NOTICE OF DECISION  
Veritas School Modular Classroom Placement – 1230 NE Bell Road  
Design Review – DR222-0008

**DECISION AND FINDINGS**  
Veritas School Modular Classroom Placement – 1230 NE Bell Road  
Design Review –DR222-0008

**REQUEST:** Placement of modular building for classroom use

SITE PLAN

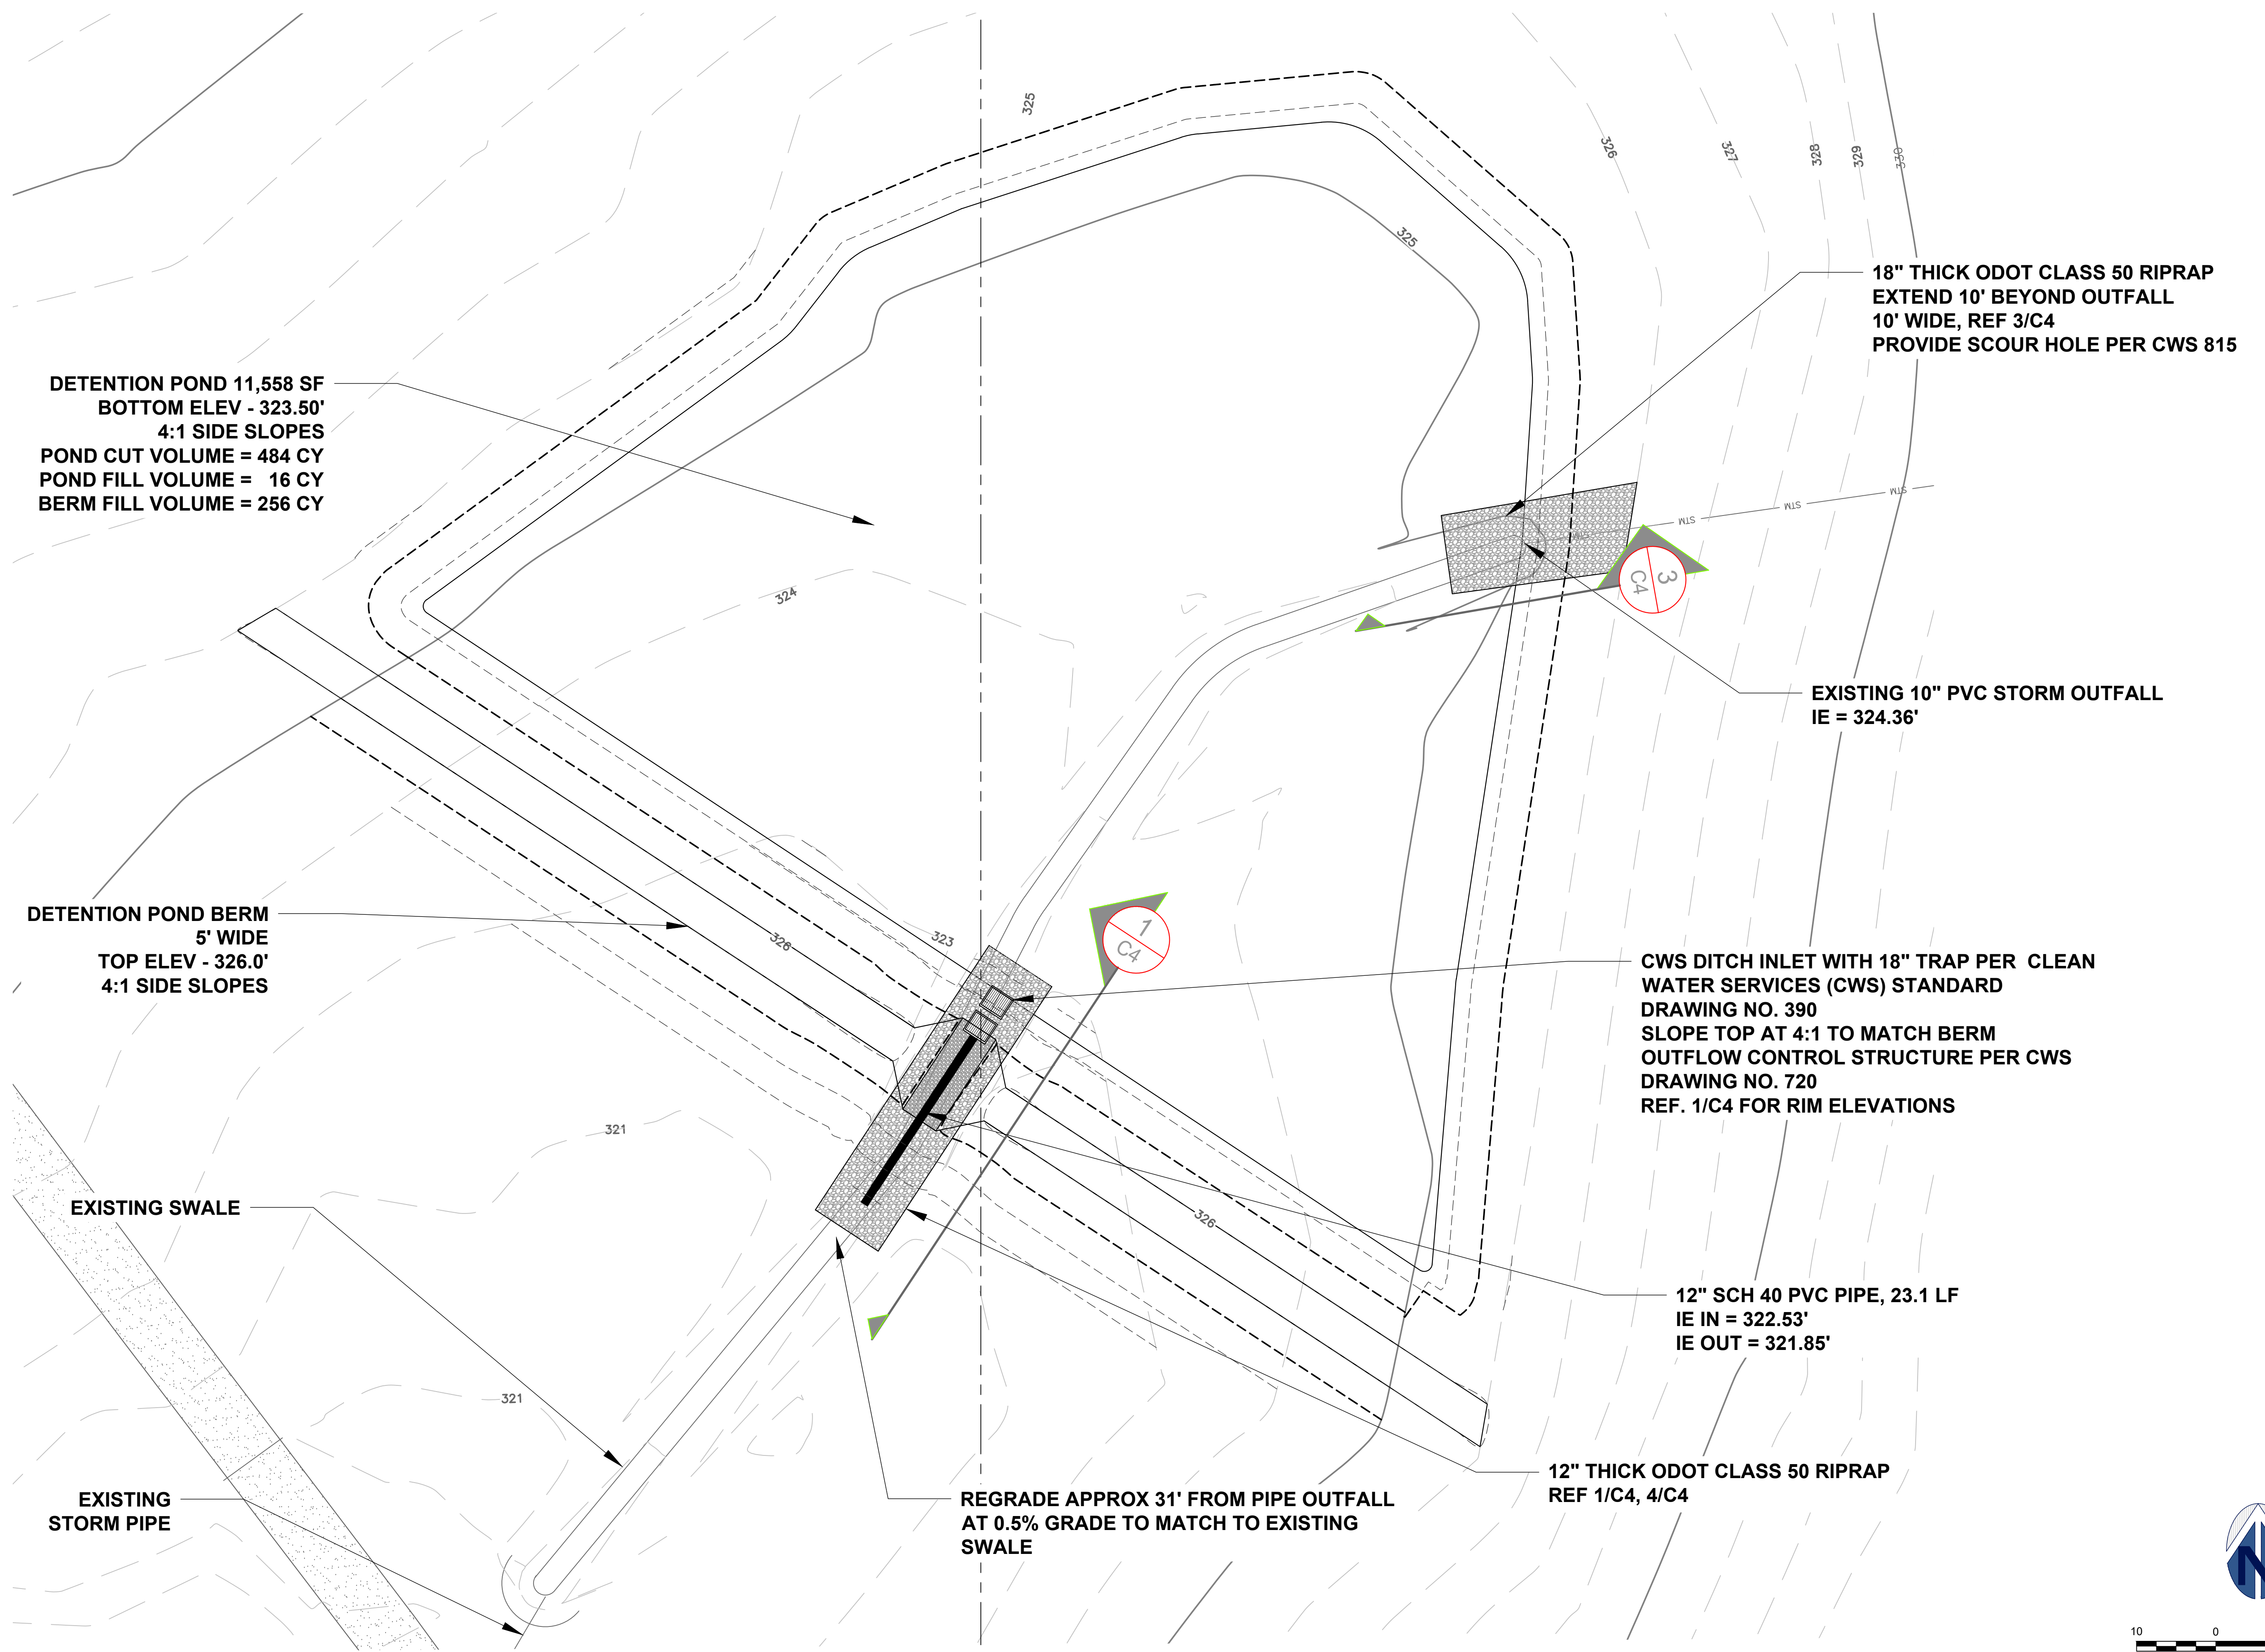
**Finding:** It is unclear if the proposed modular has adequate private walkways. The applicant’s narrative states that modular will connect to existing ADA accessible paths, however no details were shown on the site plan. A revised site plan showing accessible pathways to the modular meeting the standard of NMC 15.440.140(B) and (C) shall be submitted with building permit application plans to be reviewed and approved prior to issuance. If the aforementioned condition is adhered to this criterion will be met.

3. **Private Walkways:**
  - a. A revised site plan showing accessible pathways to the modular meeting the standard of NMC 15.440.140(B) and (C) shall be submitted with building permit application plans to be reviewed and approved prior to issuance.

SCALE: \_\_\_\_\_ DATE: \_\_\_\_\_  
 DESIGNED BY: \_\_\_\_\_  
 JOB No.: \_\_\_\_\_  
 DWG. No.: **C2**

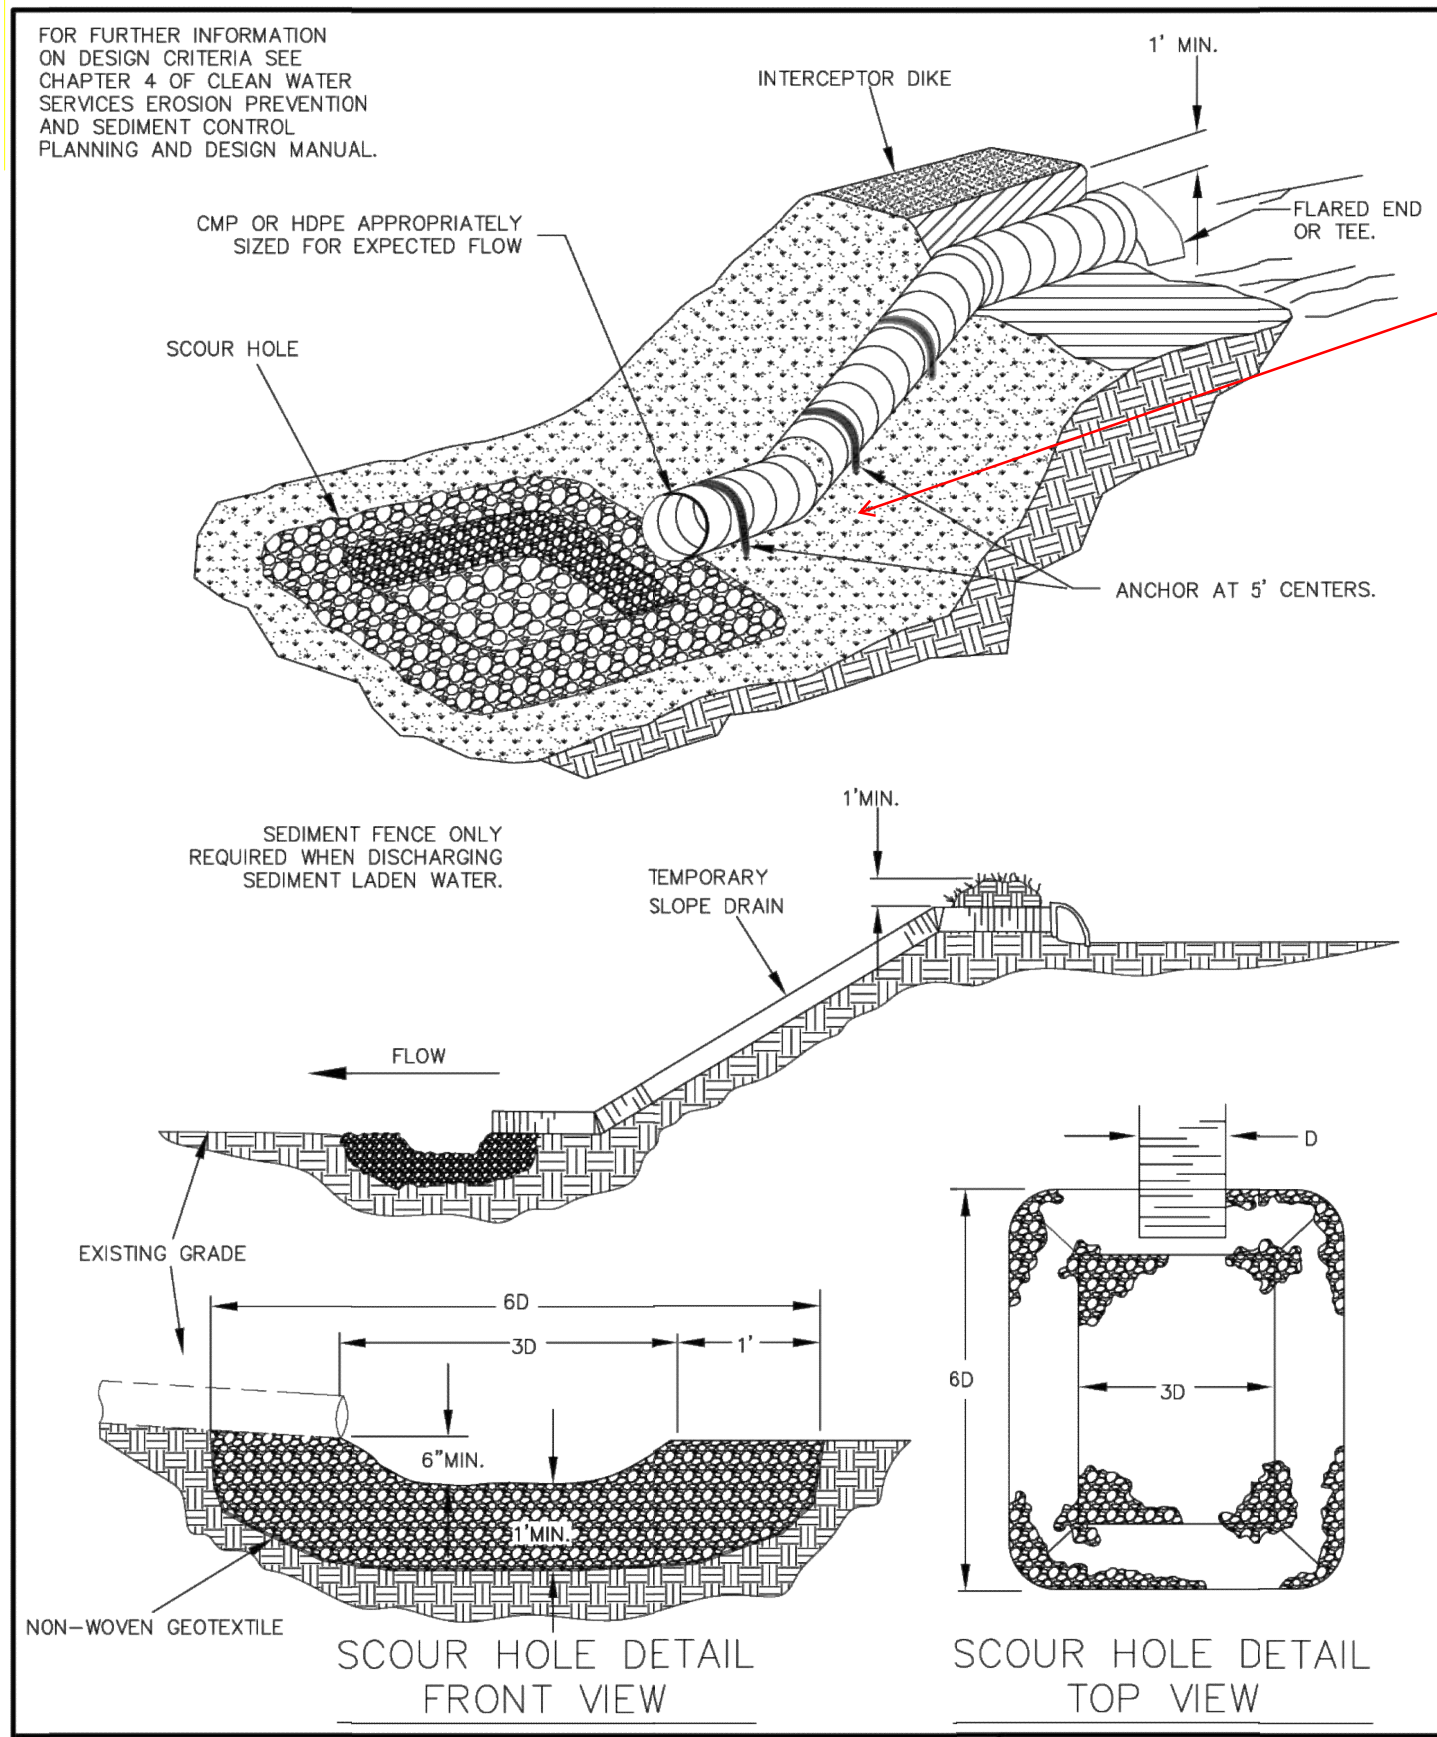
In my experience these don't work except for small pipe or flows. The amount of water that could be coming down this I would recommend a concrete structure to dissipate the energy. Plus they are much easier to maintain.
